Gdc_UbY'DUf_'6 cUfX'5[YbXU'

3:30 p.m. Thursday, Oct. 8, 2020

CITY OF SPOKANE
PARKS AND RECREATION DEPARTMENT
CHANGE ORDER NO. 06

Contractor: LARIVIERE INC.
Project: North Bank Playground
PCO 022 RFI#42 BB Court Size

Project Name:	North Bank Playground	COP No:	9
Project No.	5188-19	Date:	4.29.20
Owner:	Spokane Parks & Recreation		
Contractor:	LaRiviera	Designer:	Bernardo Wills Architects

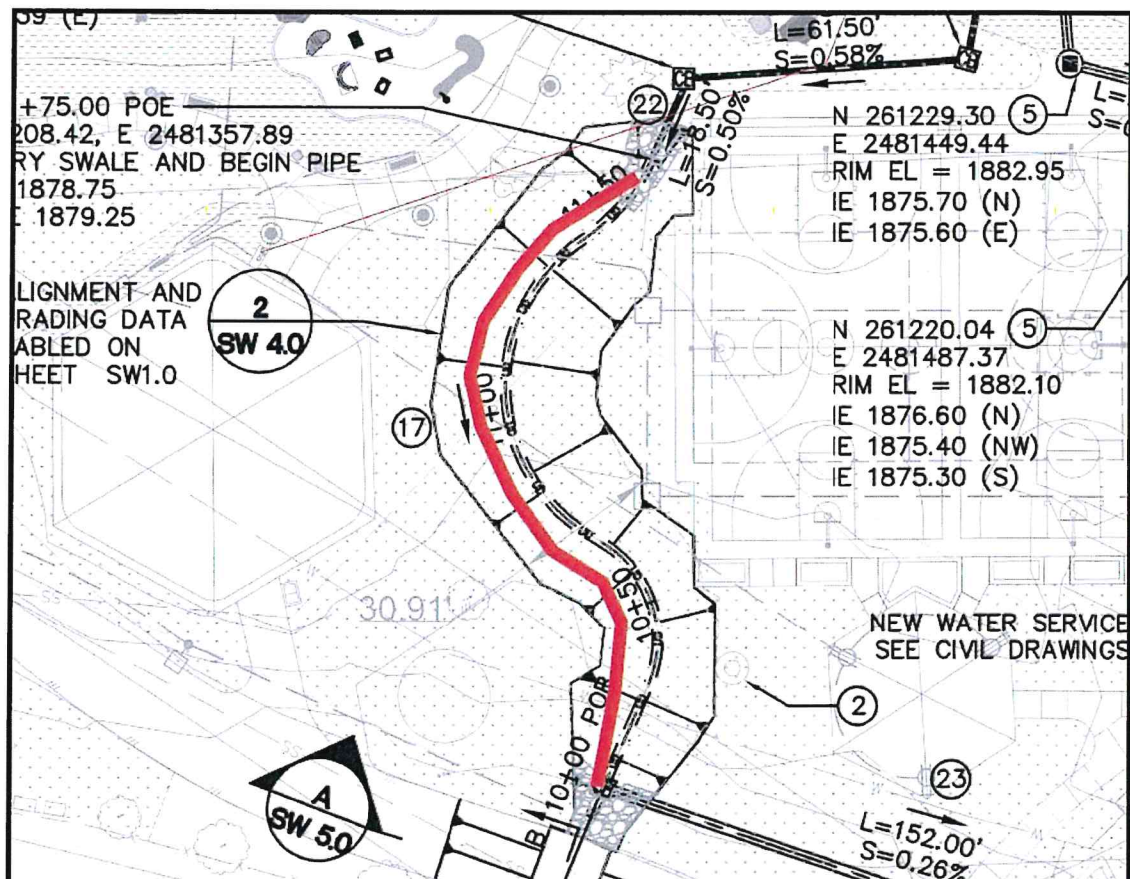
3. Concern is a nice Elm tree appears to be located in direct conflict with 24" storm line. (Action) remove tree or re-locate storm line as shown below.

4. Opportunity for significant savings by penetrating the existing manhole with new 18" storm sewer and eliminating the need for new custom manufactured structure, replacement of existing structure and need for engineered storm water bypass plan affecting project schedule. (Action) use existing storm structure as described below.

Change Order Proposal (COP)

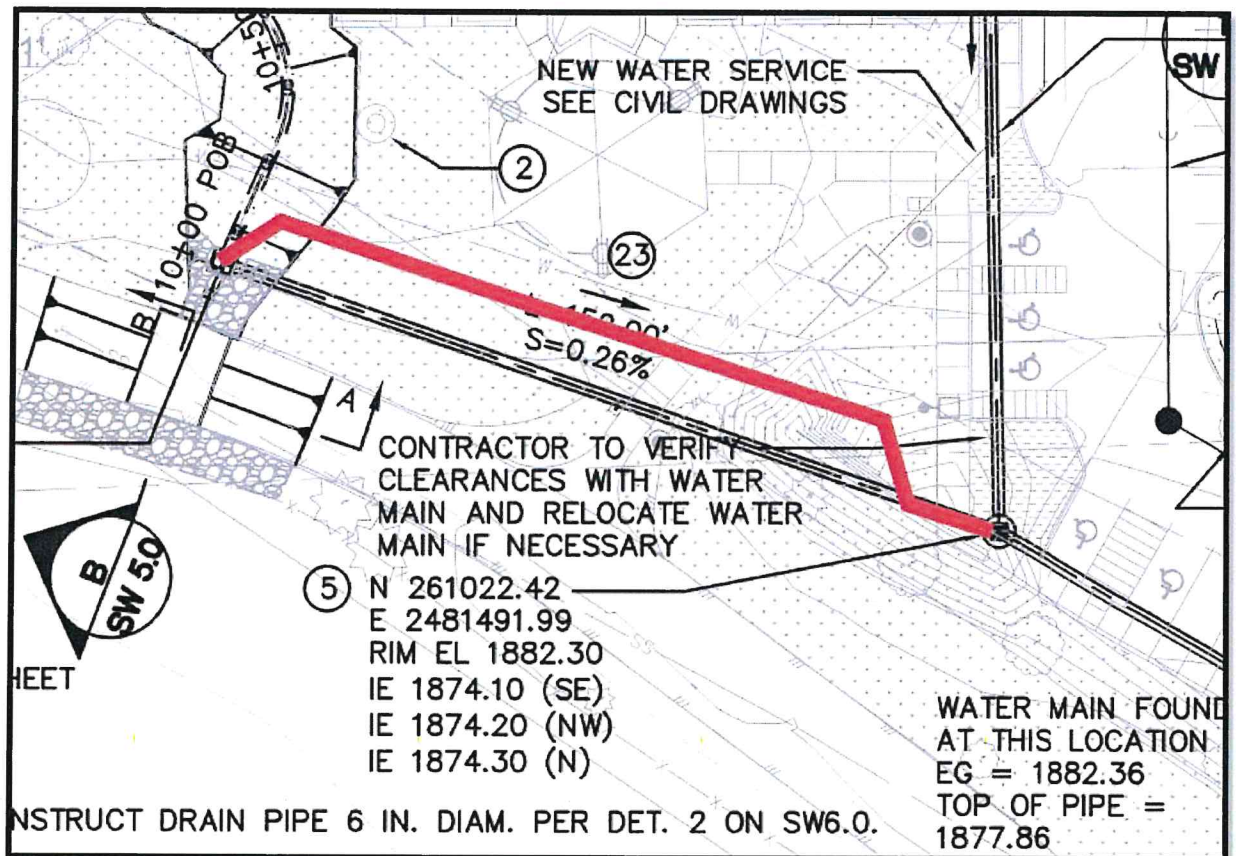
3. Due to system hydraulics, the line #23 needs to stay (in some shape or form). It is providing attenuation volume during the design storm when the river is running high. Contractor to provide cost proposal comparison pricing for Elm removal vs routing pipe around tree. For routing around tree option, change the pipe material to 24" HDPE and add three 45-degree fittings. This would need to be approved by the City and separation would need to be maintained from the water line.

4. Provide cost proposal for existing manhole at this location may remain in place. Core it for installation of the 18" DI. Try to keep the 18" line coming into the manhole as close the design IE as possible, but if that is not possible keep the 18" IE close to the top-of-bench elevation as we discussed in the field today.

- a. HDR/owners rep to provide one more inspection of the manhole from the inside to check the existing lid.
 - b. To ensure smooth stormwater flow inside the manhole the City will require a hand-formed channel at the new inlet inside the manhole. The existing manhole channel will need to be chipped to enable the new concrete material to bond with the existing. HDR/owners rep will need to observe that the demo has been properly performed before any new concrete channel material is placed. To ensure all loose/chipped material has been removed, use a stiff wire brush on the entire prepared channel area followed by vacuuming. HDR/owners rep also will need to observe any forms placed for the new channel prior to pouring. Since we are retrofitting a channel, this will be very important.

- c. A round hole (not a square hole) will need to be cut into the existing manhole to accept the new pipe. Use of a jackhammer will not be an acceptable method of creating the opening for the pipe. Non-shrink grout may be used to fill the remaining voids between the pipe and manhole. I also recommend that about 0.5 CY of unreinforced concrete (above 3,000 psi) be placed on the exterior of the manhole, surrounding the new pipe. The existing ground outside the manhole should be compacted to firm and unyielding prior to placing concrete. The new concrete will provide additional support to the new penetration should there be any ground shifting.

Project Name:	<u>North Bank Playground</u>	COP No:	<u>15</u>
Project No.	<u>5188-19</u>	Date:	<u>8.6.20</u>
Owner:	<u>Spokane Parks & Recreation</u>		
Contractor:	<u>LaRiviera</u>	Designer:	<u>Bernardo Wills Architects</u>

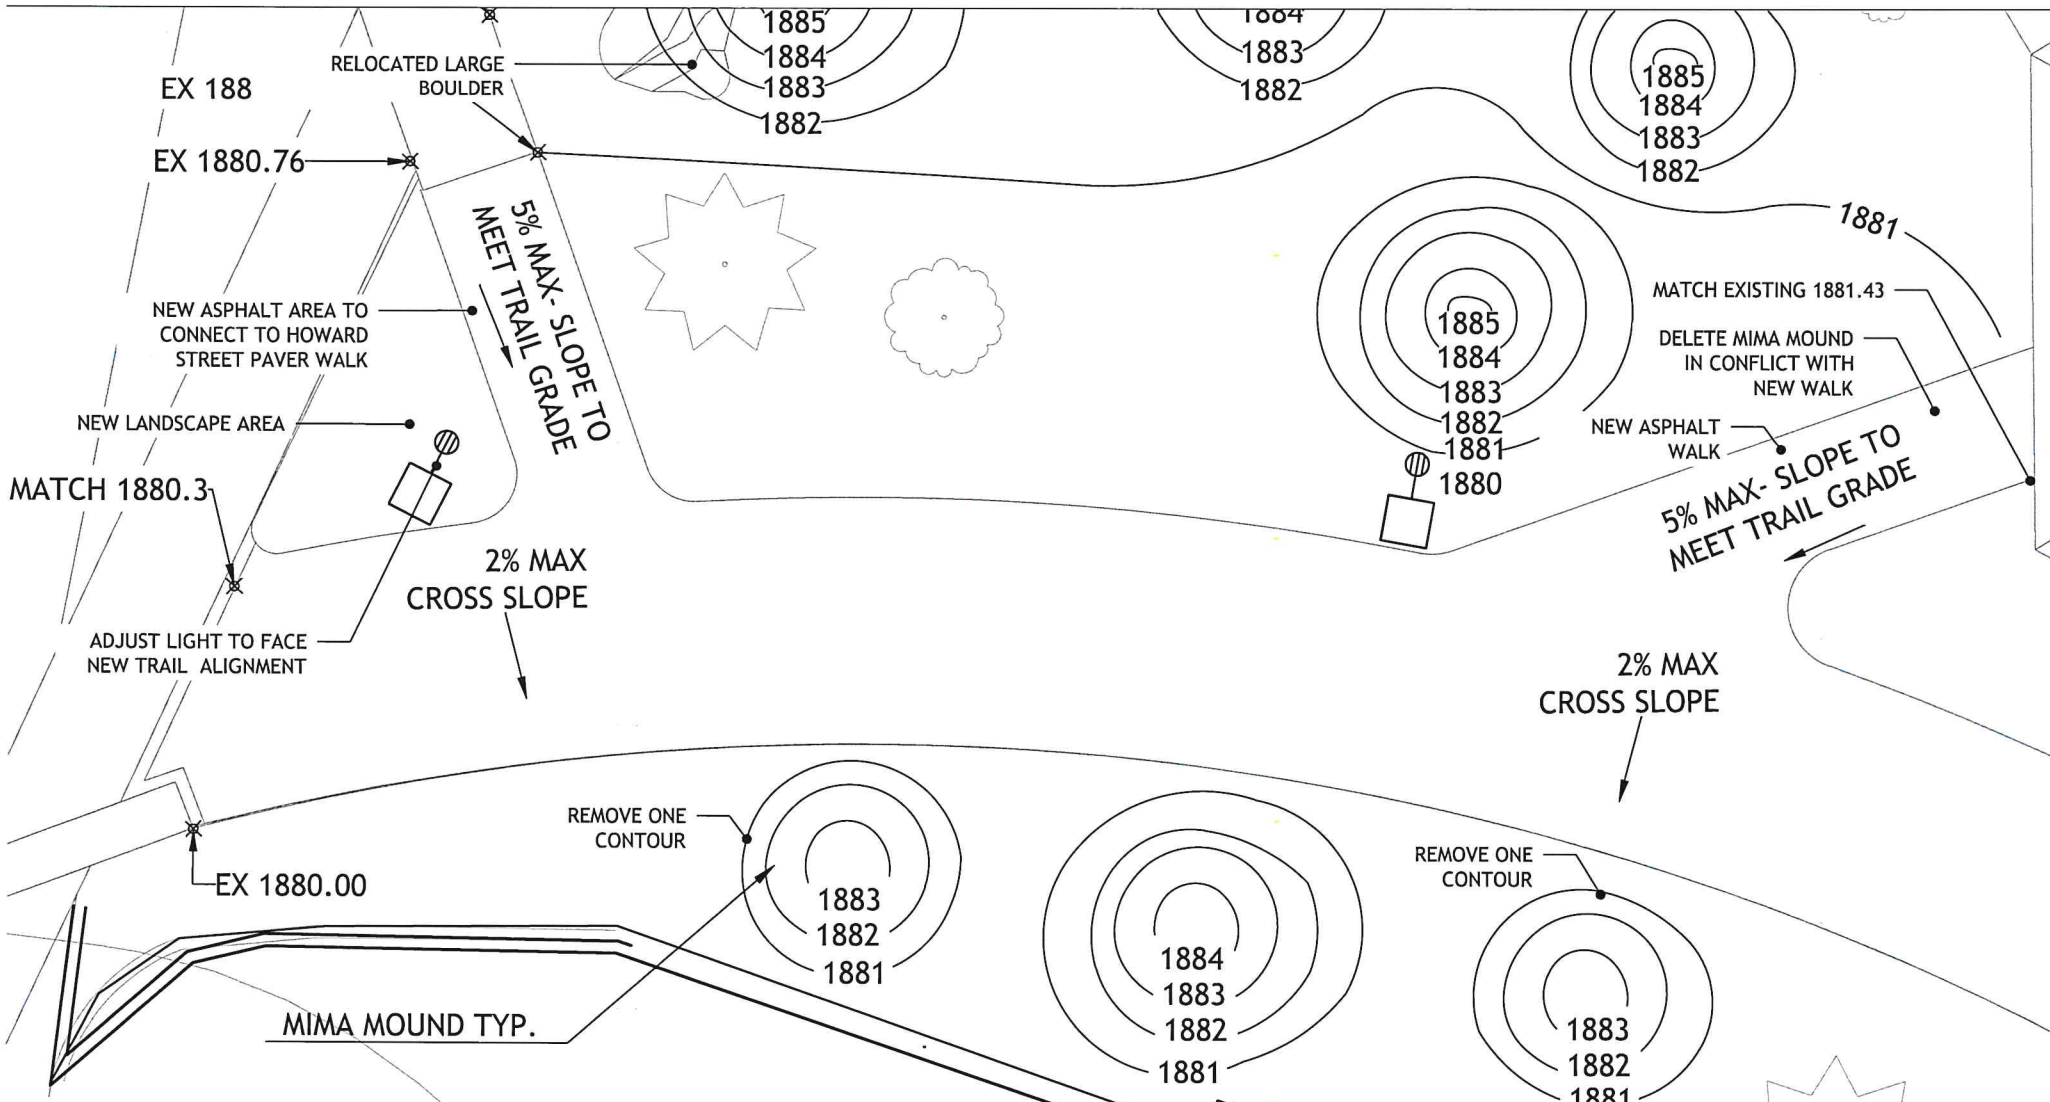
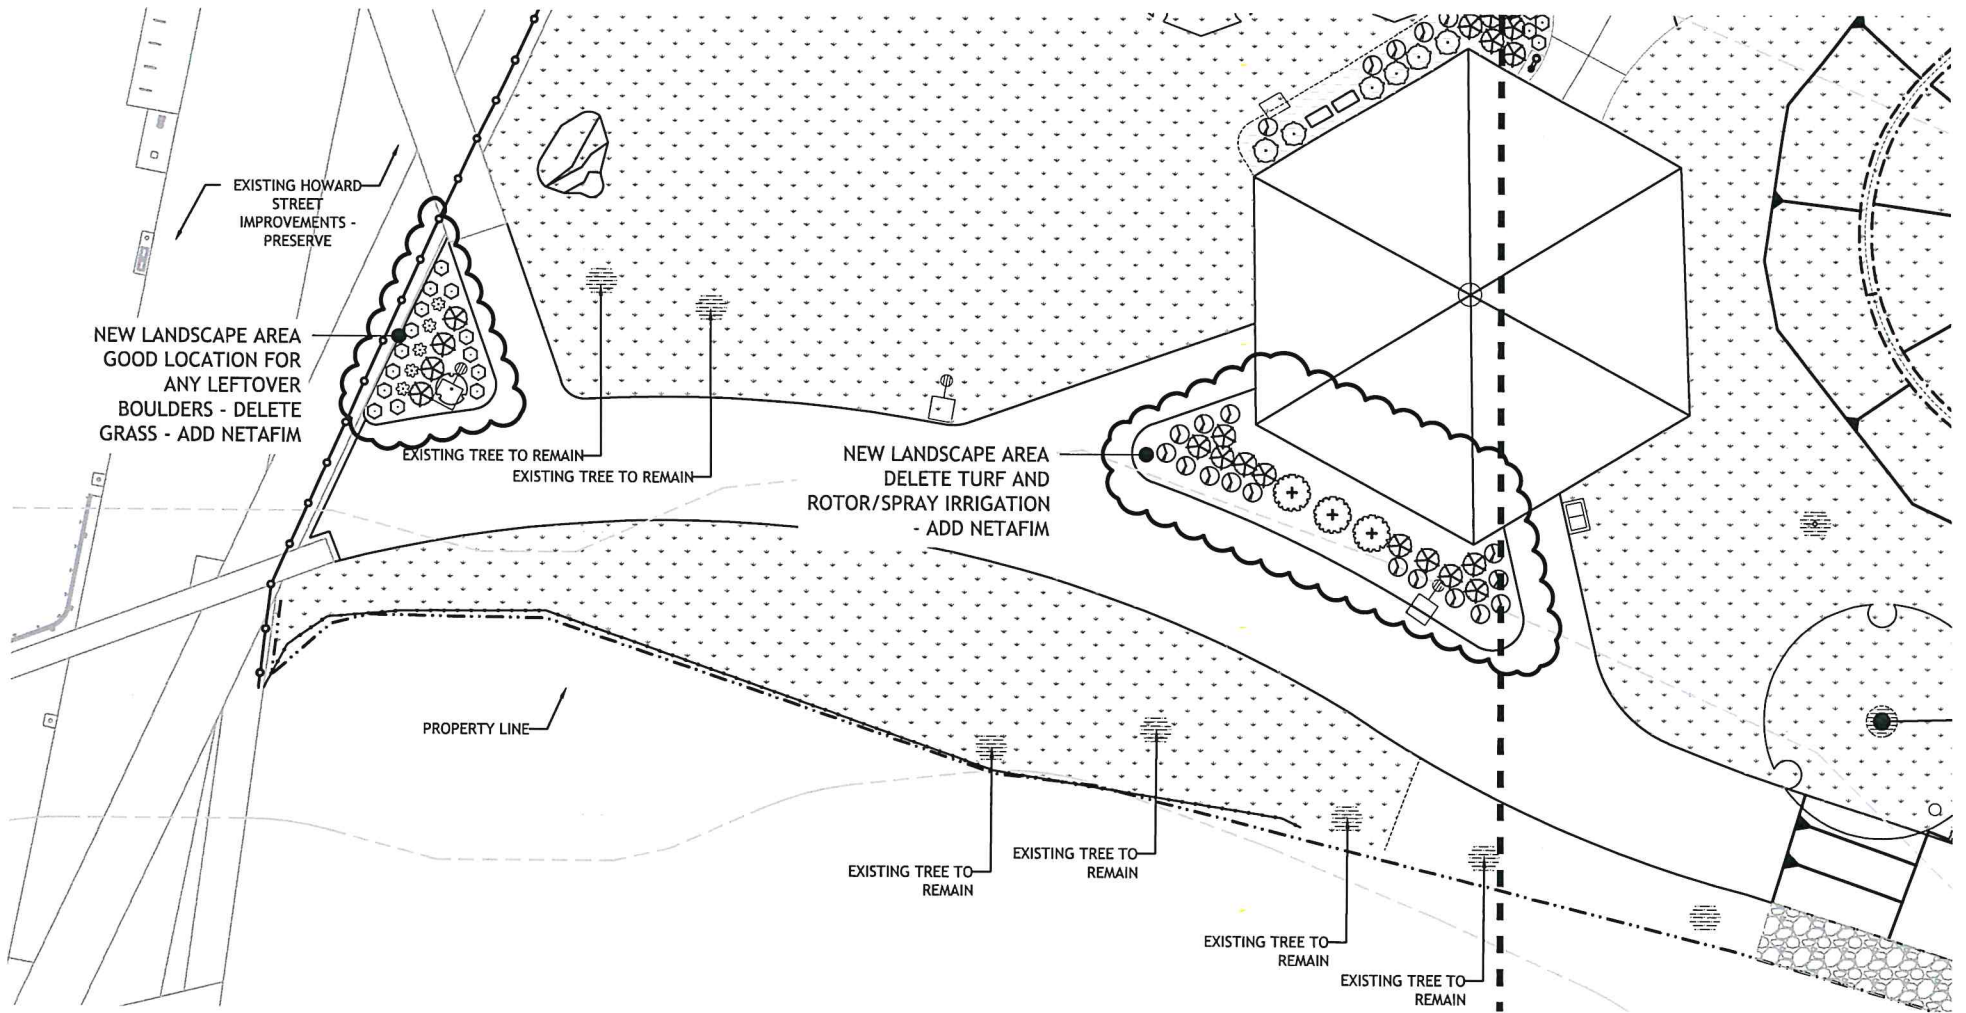
Description: Trail Adjustments

1. Adjust centennial trail to move approximately 4' to the south to avoid existing tree roots.
2. Add asphalt walk off Howard St. Promenade and west side of large picnic shelter. Approximately 768.5 SF additional asphalt combined.
3. Remove one mima mound in conflict with new walk off of west side of picnic shelter. Reduce height of two mima mounds south of the centennial trail to accommodate new trail alignment.
4. Deduct turf and spray/rotor irrigation at new landscape bed south of picnic shelter and at trail intersection with Howard St. Promenade.
5. Add topsoil, mulch, plantings and Netafim at new landscape beds mentioned above.

Justification: The civil/stormwater engineer advised against capping the entire channel with topsoil for plant growth due to a concern over future maintenance. The city and design team had a desire to still include some plant material and visual interest in the channel, replacing the originally planned plantings.

1 FENCE CLARIFICATION

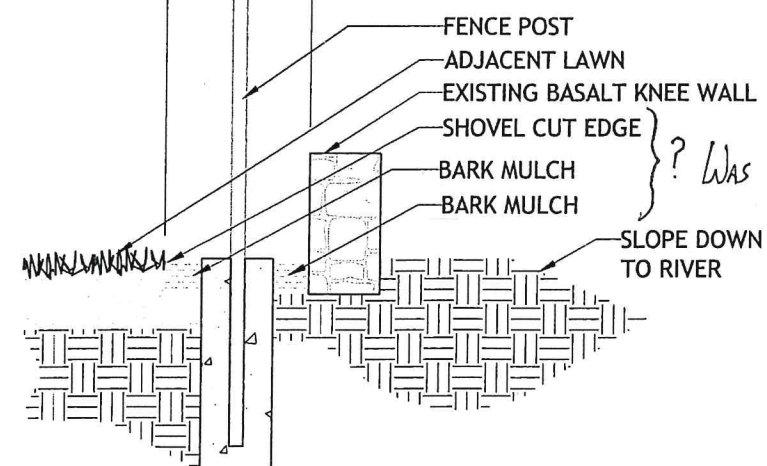
EXISTING BENCHES -
REMOVE AND FURNISH
TO OWNER

NEW 3'
MAN GATE
TIE IN POINT
WITH
EXISTING
FENCE
